Re: Whitewood Creek Restoration Bid Package 2, Request for Proposal 1

## **REQUEST FOR PROPOSAL**

Whitewood Creek Restoration – BP #2

**PROPOSAL REQUEST NO:** 1

NOTE: AREA JUST UPSTREAM FROM PHOTO ON PAGE 3.

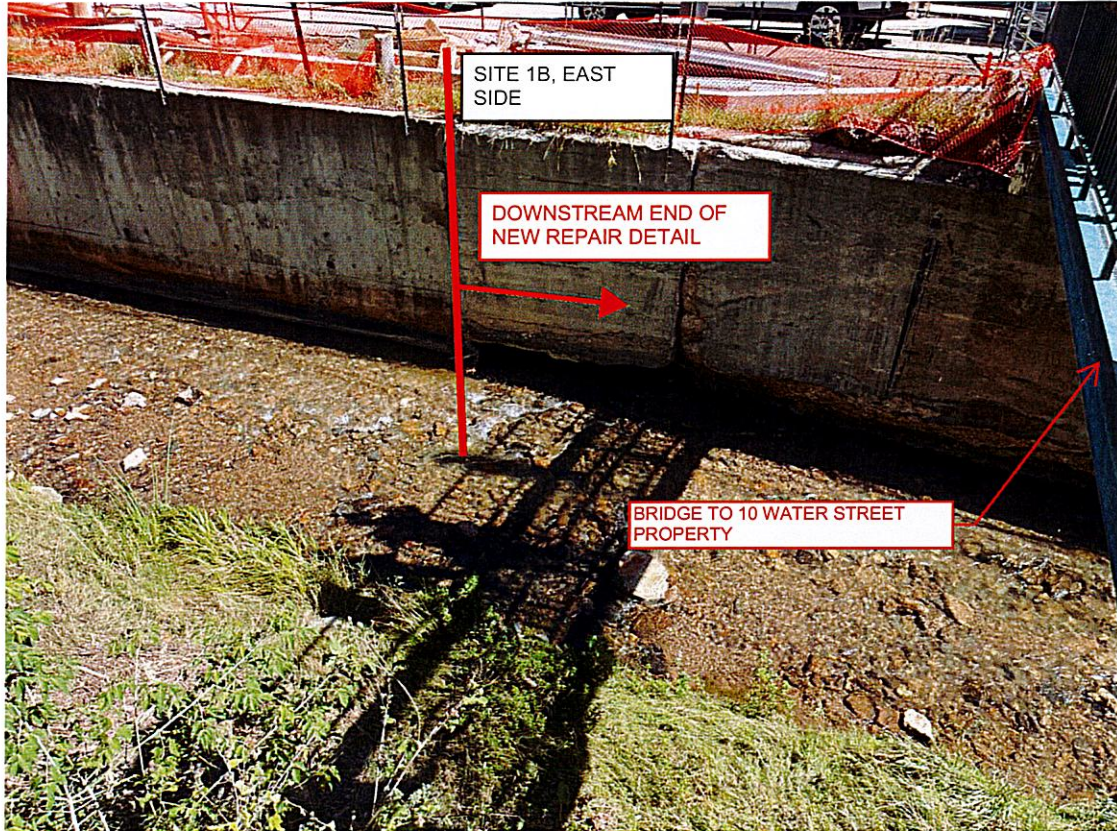
1. The existing single row gabion blocks on the east side of Site 1A were recently removed from the site by Contractor. With the gabion baskets removed, the condition of the bottom of existing retaining is exposed. Upon further investigation, the wall appears to be in adequate condition with no visible signs of flood damage or undercutting from erosion. Jared Schippers observed an excavator operator test digging in a couple of locations to verify solid bedrock adjacent the bottom of the footing (August 28, 2024). As such, the precast concrete row of blocks as indicated on Sheet S-101 shall be omitted from the project. We understand the precast blocks have already been furnished and stained. For this Proposal Request item, provide a credit proposal to omit the placement of the blocks and cast-in-place concrete cap. The City will take possession of the blocks. Contractor to deliver the blocks to the City storage yard.
